Access Compliance Report

Public Rights-of-Way

(Curb Ramps)

Intersection ID: 15889	Main Street: HERTFORD_RD	Cross Street: PEMBROKE_AV	Location: NE
ADA ID: CFB03758B5C1	Ramp Type: Directional1	Initial Pass/Fail: Fail	Overall Compliance: No
Severity Score: 58.75			
Codes/Mitigation Info/Possible Solution		Field Measurements/Component Compliance

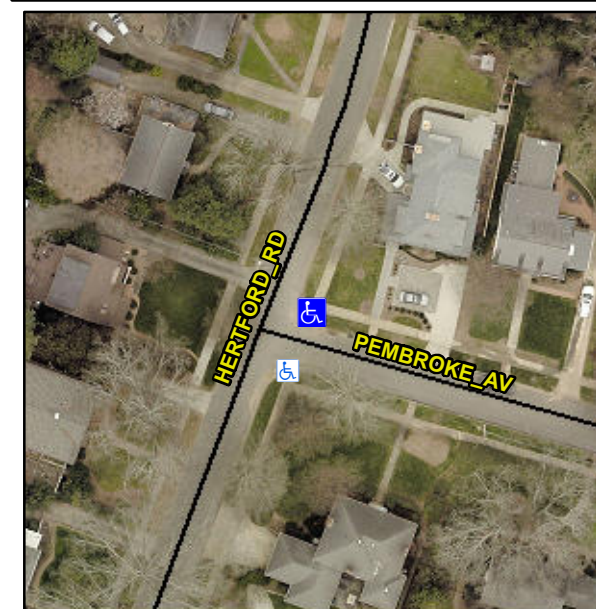
R304.5.1, R304.2.2, R304.5.3

Compliance	Description	Data	Compliance	Description	Data
N/A	Ramp Length (in)	42.0	N/A	Grade Break?	N/A
No	Ramp Width (in)	42.0	N/A	Grade Break Slope (%)	0.0
No	Ramp Slope (%)	15.6	N/A	Grade Break XSlope (%)	0.0
No	Ramp XSlope (%)	9.1			
N/A	Flare Type LT	N/A	N/A	Flare Type RT	N/A
N/A	Flare Slope LT (%)	N/A	N/A	Flare Slope RT (%)	0.0
N/A	Flare Traversable LT?	N/A	N/A	Flare Traversable RT?	N/A
N/A	Landing Length (in)	0.0	N/A	DWS Provided?	N/A
N/A	Landing Width (in)	0.0	N/A	DWS Contrast?	N/A
N/A	Landing Slope (%)	0.0	N/A	DWS Length (in)	N/A
N/A	Landing X Slope (%)	0.0	N/A	DWS Full Width?	N/A
N/A	Landing Curb? (Y/N)	N/A	N/A	DWS Offset LT (in)	N/A
N/A	Shared Landing?	N/A	N/A	DWS Offset RT (in)	N/A
N/A	Gutter Ponding?	0.0	N/A	Gutter Slope (%)	N/A
N/A	Gutter Lip Ht (in)	0.0	N/A	Gutter X Slope (%)	N/A
N/A	Painted X Walk1?	No		Road Slope (%)	3.0
	X Walk 1 Direction	To S		Road X Slope (%)	0.3
	X Walk 1 Width (in)	N/A		Clear Space?	N/A

X Walk 1 Slope (%)	3.0	N/A	Clear Space to XWalk (in)	N/A
	X Walk 1 X Slope (%)	0.3	N/A	Storm Grate/Utility Hazard?	N/A
N/A	Ramp inside XWalk1?	N/A		Storm Grate/Utility Type	
N/A	Any Obstructions?	N/A			N/A
	Obstruction Type		Yes	Surface Condition? (G/P)	Good
			N/A	Curb Slope (%)	12.5

Remove & Replace Entire Ramp.
